November 9, 2015

RE: Public Notice SPK-2008-00861 – California WaterFix

SolAgra Water Solution (“SWS”) – the Least Environmentally Damaging Practicable Alternative (“LEDPA”) to the California Water Fix (“CWF”).

Figure 13-1: Known Gas Wells and Fields in the Delta Region

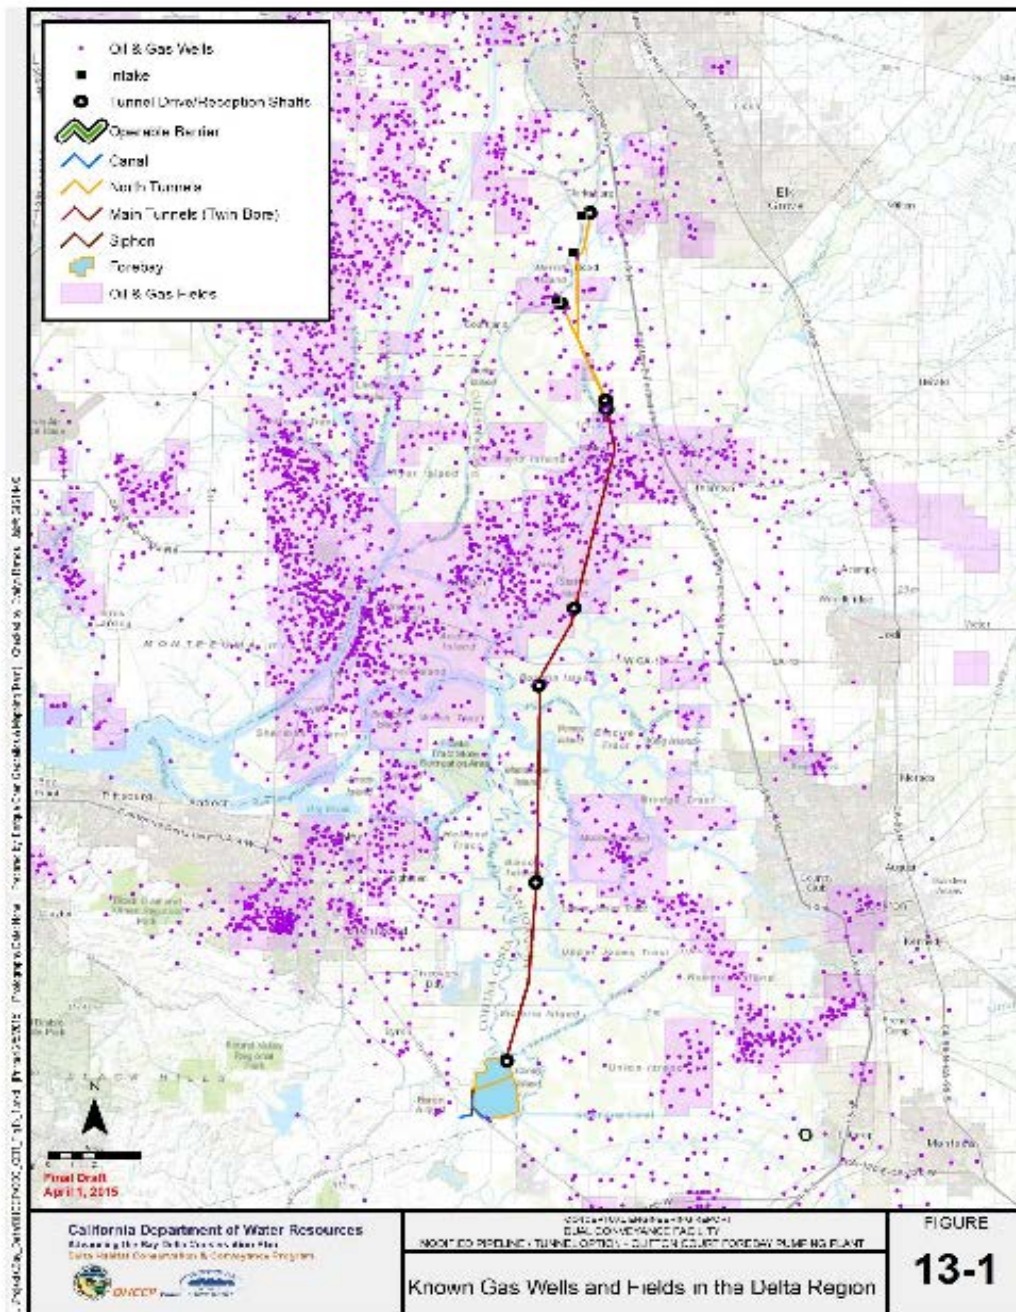
- The tunnel path for Alternative 4A passes through one of the largest natural gas fields in the western United States. This field has active gas wells that are in the path of the proposed CWF tunnels. This makes the probability of successfully advancing tunnels of this size and length without asphyxiating the tunnel crews, and/or creating underground explosions even lower than the chances of success of Big Bertha in Seattle. It should also be noted that Big Bertha cost \$80 Million to purchase and took 3 years to build. The CWF proposes to use nine EPB-TBMs.

The areas shown on the “Known Gas Wells and Gas Fields in the Delta Region” above show the location of known gas wells in dark purple dots. The areas in light purple are the actual subterranean gas fields. Pockets of natural gas occur in the general area of these gas fields. These randomly occurring and moving gas pockets are typically uncharted. Although these wells are thousands of feet deep, the natural gas may be found at virtually any depth in these gas laden areas. A tunnel being advanced through this area would be subject to unknown gas “pockets” that can exist at any depth.
